Grange Road Cycle Route
– Stage 1 Road Safety Audit

AECOM has been commissioned by South Dublin County Council (SDCC) to undertake a Stage 1 Road Safety Audit of the proposed cycle/pedestrian scheme on Grange Road in Rathfarnham, Co. Dublin.

4.1.1 Problem		
<i>Location:</i>	Stonepark Abbey to Dispensary Lane	
<i>Drawing:</i>	Drg. No. 60302419_P_001, General Arrangement Sheet 1	
<i>Summary:</i>	The potential speed of motorists through this part of the road carriageway.	
<i>Description:</i>

Figure: Existing and Proposed Ramps on Grange Road

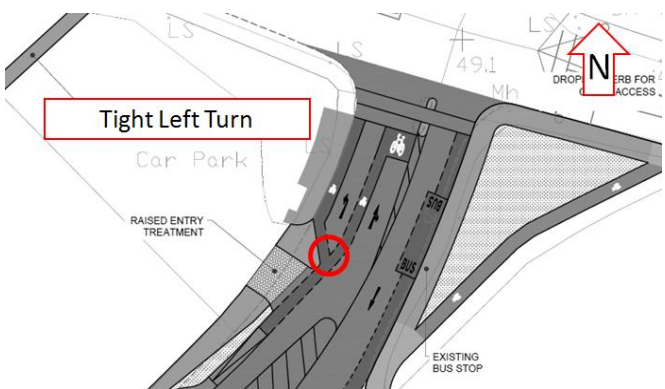
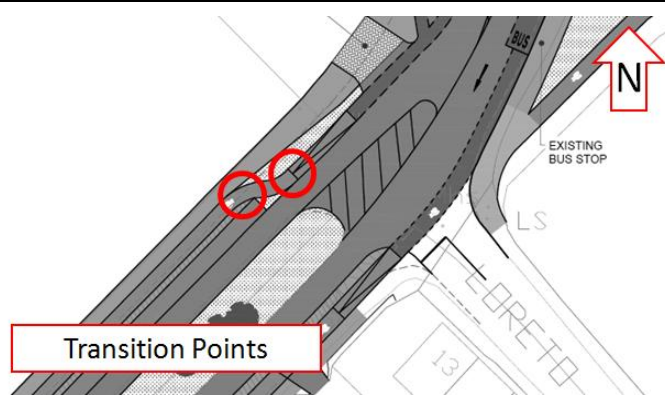
Two shared spaces are proposed along this proposed scheme, the first from Park Avenue to Sarah Curran Avenue, and the second from Stonepark Abbey to Dispensary Lane. Where shared space is being provided the safety of cyclists needs to be supported by speed management for bus services and other vehicles.

Between Stonepark Abbey to Dispensary Lane it is proposed to remove two existing ramps on the road carriageway but replace these with two new bus friendly ramps. It is acknowledged that there are other speed reducing measures such as narrowing of the road carriageway proposed. However, the proposed ramps are located 160m apart. There is a risk that the speeds through the shared space area will be excessive, which could increase the risk of and severity of collisions with cyclists.

Consideration should be given to providing additional speed reducing measures, such as additional ramps along this section of the road carriageway. Signage should be provided to indicate to motorists that they are entering a cycle friendly zone.

However, if the scheme should go ahead as currently proposed, the speed at which motorists drive through this section of the road should be monitored.

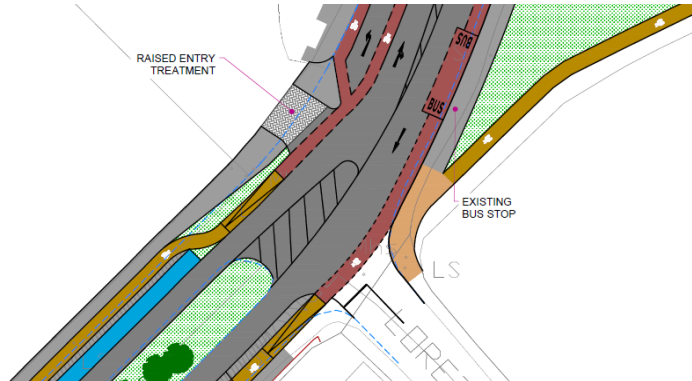
4.1.5 Problem		<p>Figure: Visibility May be Impeded by Proposed Tree</p>
<i>Location:</i>	Grange Road / Nutgrove Avenue Approach	
<i>Drawing:</i>	Drg. No. 60302419_P_001, General Arrangement Sheet 1 of 3	
<i>Summary:</i>	Impeded Exit Visibility.	
<i>Description:</i>		
<p>A tree is proposed outside a residential access. However, visibility to the left on exit (to the north) may become impeded due to the growth of the tree. It is unclear if this vegetation is to be cut back and maintained. This may lead to inappropriate exiting manoeuvres resulting in collisions with through traffic.</p>		
Recommendation:		
<p>Visibility of, and from, the junction should be clear and unobstructed, in accordance with traffic speeds and the requirements of the relevant design guidance. All vegetation should be cut back sufficiently, and adequately maintained, to ensure adequate visibility splays are provided.</p>

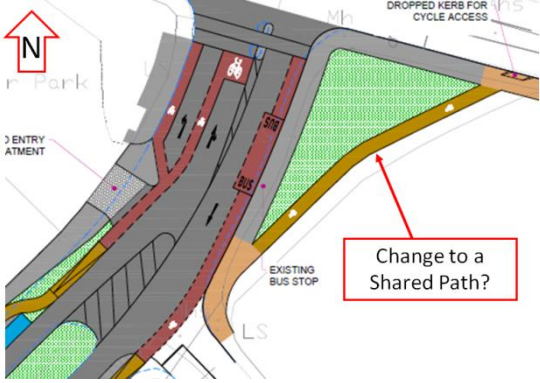
4.2.4 Problem		 <p>Photo: Parking noted south of St. Enda's Drive on Grange Road</p>
<i>Location:</i>	Grange Road, throughout the length of the scheme	
<i>Drawing:</i>	Drg. No. 60302419_P_001, General Arrangement Sheet 1 to 3	
<i>Summary:</i>	Illegal parking on the cycle lane / tracks	
<i>Description:</i>		 <p>Photo: Parking noted at Convent Lane</p>
<p>Parking has been noted on the along the Grange Road. Parking is not permitted on cycle lanes/tracks, but motorists may park on the proposed cycle facilities. Parking in the cycle facilities will result in cyclists moving either onto the road carriageway or the footpath, putting them into conflict with either motorists or pedestrians respectively.</p>		
Recommendation:		
<p>Measures should be provided to discourage motorists from parking on the cycle facilities along Grange Road.</p>

Figure: Proposed Cross Section on Grange Road

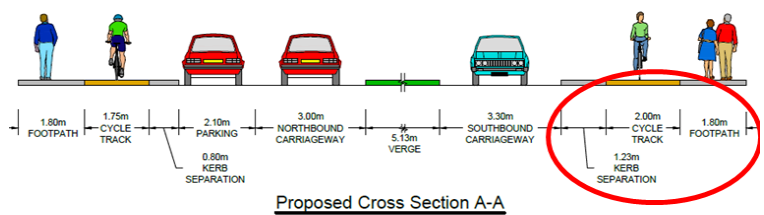
4.3.4 Comment	
Location:	Grange Road at Section A-A
Drawing:	Drg. No. 60302419_P_001, General Arrangement Sheet 1 of 3
Summary:	Reduced Pedestrian Footpath
Description:	
<p>It is proposed to slightly reduce the existing pedestrian footpath on this section of the route. However, it is proposed to provide a kerb separation of 1.23m wide on the eastern side of the road, which is not required. The proposed footpath width should be maximised to wide as possible.</p>	
Recommendation:	
<p>A clear width of 2000mm is recommended in the National Disability Authority's "Building for Everyone" to enable people to walk alongside each other and for two wheelchair users or parents with strollers to pass comfortably.</p>

Figure: Proposed Cross Section on Grange Road

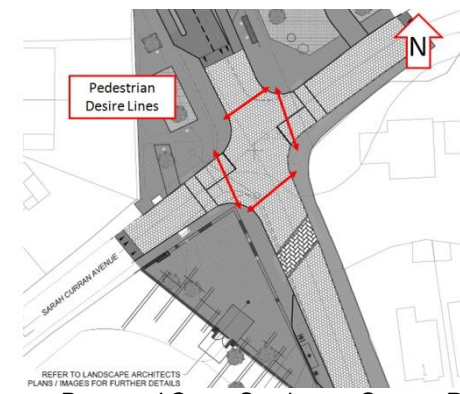
4.3.5 Problem	
Location:	Grange Road / Sarah Curran Avenue
Drawing:	Drg. No. 60302419_P_001, General Arrangement Sheet 2 of 3
Summary:	Proposed Pedestrian Crossing off the Desire Line
Description:	
<p>The crossings at this junction are located off the pedestrian desire lines. Significant proportions of pedestrians and cyclists will not inconvenience themselves by travelling the extra distance to formal facilities and may be prepared to take the risk of crossing away from the formal crossing point. With pedestrians crossing at numerous locations it will increase the risk of a collision with vehicles.</p>	
<p>An uncontrolled crossing has not be provided on the northern side of the junction.</p>	
Recommendation:	
<p>It is important that crossings are sited where the maximum number of people are likely to use them. The uncontrolled crossings should be sited closer to the pedestrian desire line.</p>	
<p>An uncontrolled crossing should be provided on the northern side of the junction.</p>

Figure: Proposed Cycle Lane

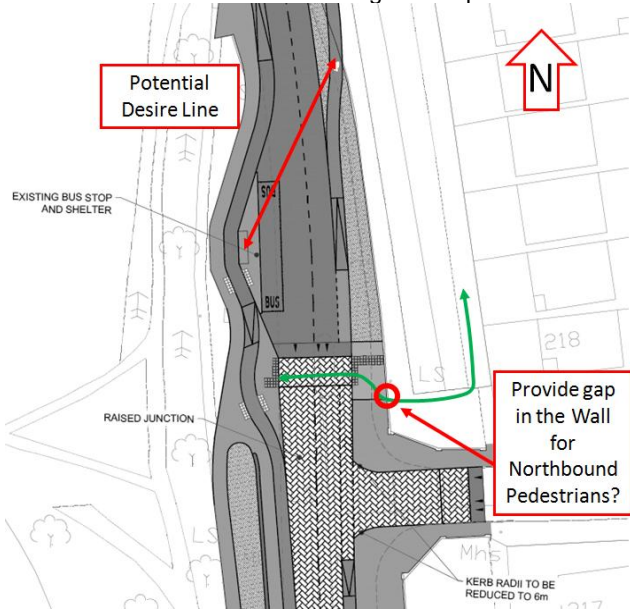
It is proposed to provide a controlled crossing to the north of the Hermitage Avenue junction. However, some pedestrians were noted to cross the Grange Road further north. The proposed crossing won't provide a direct route for northbound pedestrians. Therefore, many pedestrians will continue to cross to the north of the bus stop where they will be at risk of collision with vehicles.

To reduce the distance northbound pedestrians must walk, and to reduce the number of pedestrian who do not use the controlled crossing, consideration should be given to providing a gap through the existing wall into the residential estate.
